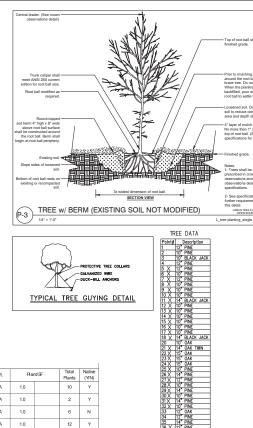
REMARKS: Will there be any garbage collection area? All garbage collection areas, utility areas, and exterior air condition components shall meet buffering/screening requirements in LDC Sec. 6.8.9 8/18 label buffer type. (type C)

10/21 label the type of landscape buffer(s) on plan.

REMARKS: 1.Type A buffer (plans submitted prior to code change) required along west buffer.

IRRIGATION PLAN: SCALE: 1" = 20'

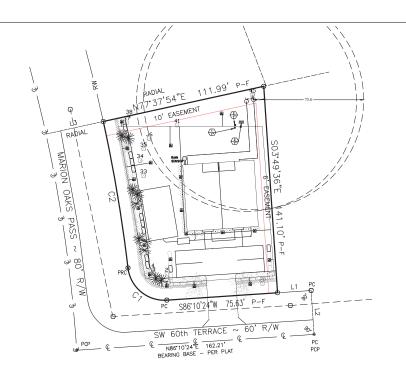
REMARKS: Plan to be revised for additional required plantings

REMARKS: 10/16/25 Need total Irrigated Square Foot listed on the plans. 5/8" Irrigation with BFPD now shown on plans. 8/18/25 Need to show irrigation and back flow meter on Water Main Extension Plan sheet,

wherever you put the meter bank. 7/1/25 Will this property be irrigated? And if so, how?
